UNITED STATES PATENT AND TRADEMARK OFFICE

10/573,302

Office Action Summary	Application No. 10/573,302	Applicant(s) ALON ET AL.	
	Examiner James M. Robinson	Art Unit 3772

DETAILED ACTION

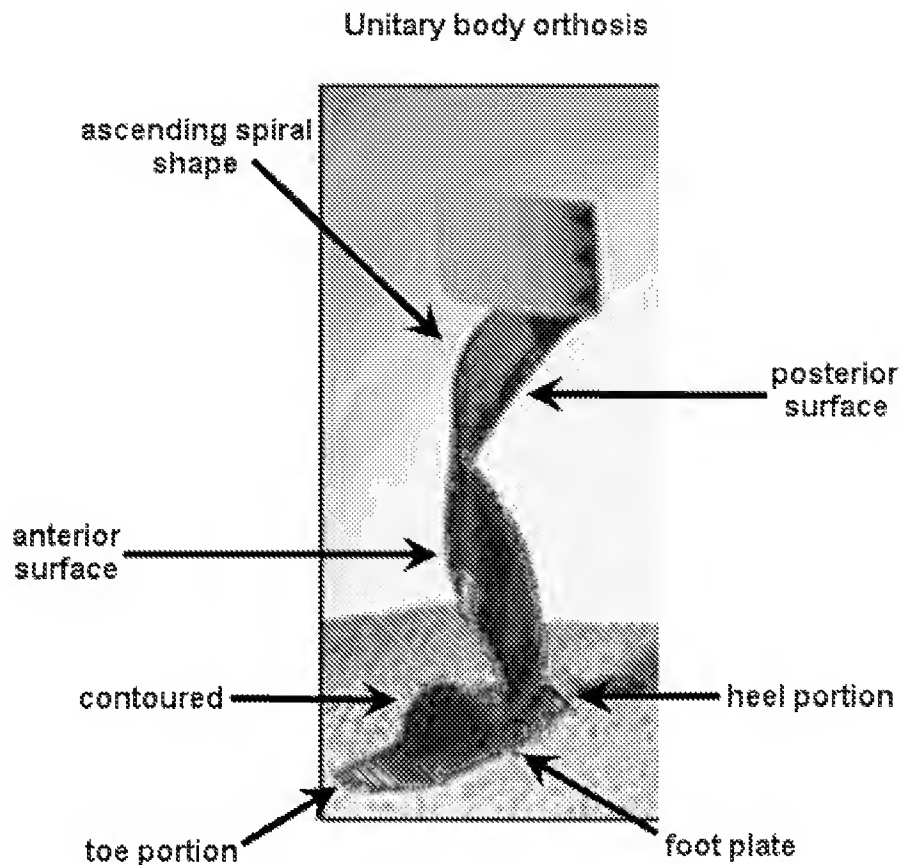
Regarding claim 1, Michael discloses an orthosis comprising a single, unitary body comprising: a generally spiral-shaped lower leg portion that, when the orthosis is worn by a wearer, covers at least a portion of the anterior surface of the wearer's lower leg and at least a portion of a posterior surface of the wearer's lower leg; and a foot plate portion that, when the orthosis is worn, accepts the wearer's foot, wherein the lower leg portion is configured to spiral upward from the foot plate portion and make contact with an anterior surface of the wearer's lower leg prior to making contact with a posterior surface of the wearer's lower leg as the lower leg portion ascends (see fig. below).

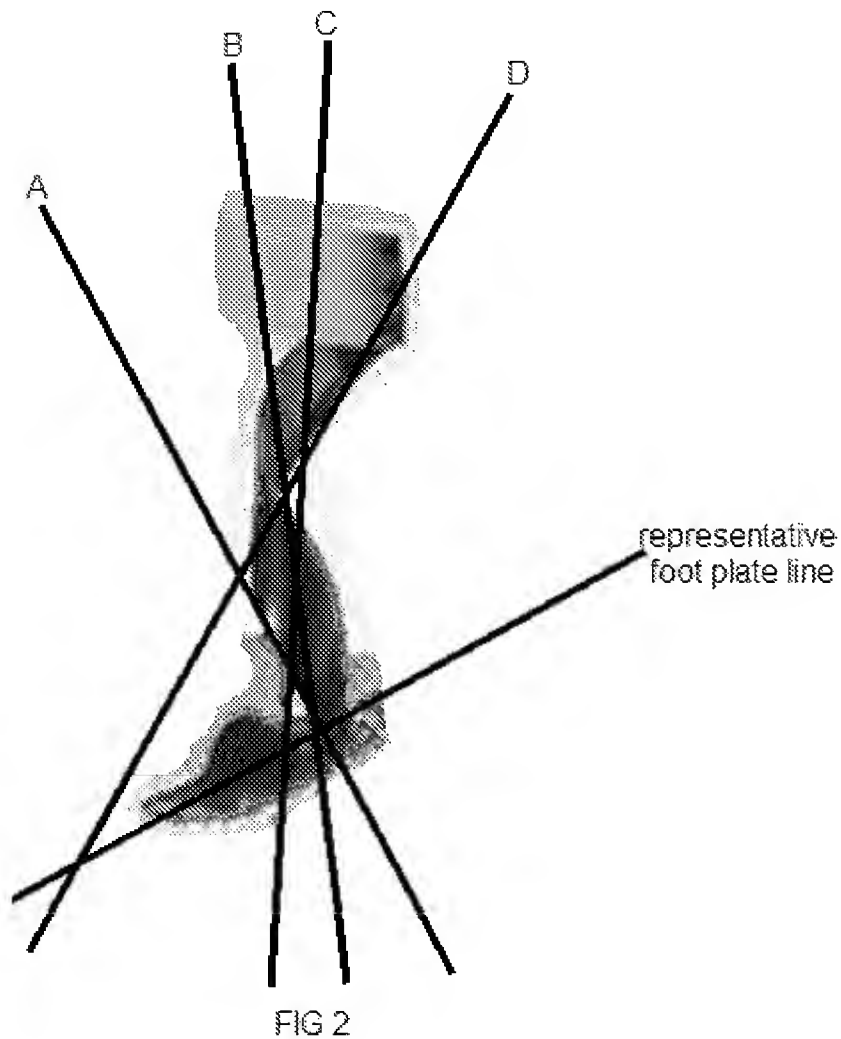
Further, Michael discloses wherein the foot plate portion and an axis of the spiral-shaped lower leg portion are disposed at an acute angle with respect to one another and wherein a difference between the angle and 90 degrees is greater than about 2 degrees to inhibit hyperextension of the wearer's knee. Please refer to figure 2 below for illustrative purposes. Any one of the lines labeled A, B, C, and D can possibly be referred to as "an axis of the spiral-shaped lower leg portion". It is clear that an acute angle wherein a difference between the angle and 90 degrees is greater than about 2 degrees is disclosed. Further, it should be noted that each of these lines A, B, C, and D

actually create two angles. If one of these angles is obtuse, it is inherent that its supplementary angle is acute.

complement at least a portion of a plantar surface of the wearer's foot so as to permit the wearer to wear shoes or sandals (see fig. above).

Regarding claim 4, Michael discloses an orthosis wherein the lower leg portion comprises an ascending section that extends from the foot plate section and curves toward the anterior surface of the wearer's lower leg to form a shin section (see fig. above).

Regarding claim 5, Michael discloses an orthosis wherein, from the shin section, the lower leg portion spirals around at least a portion of a lateral surface of the wearer's lower leg and transitions into a calf section (see fig. above).

portion nears the calf of the wearer (see fig. above). The degree of the angle of the spiral at the calf is less than the degree of the angle at the shin. This change in the degree of the angle is gradual.
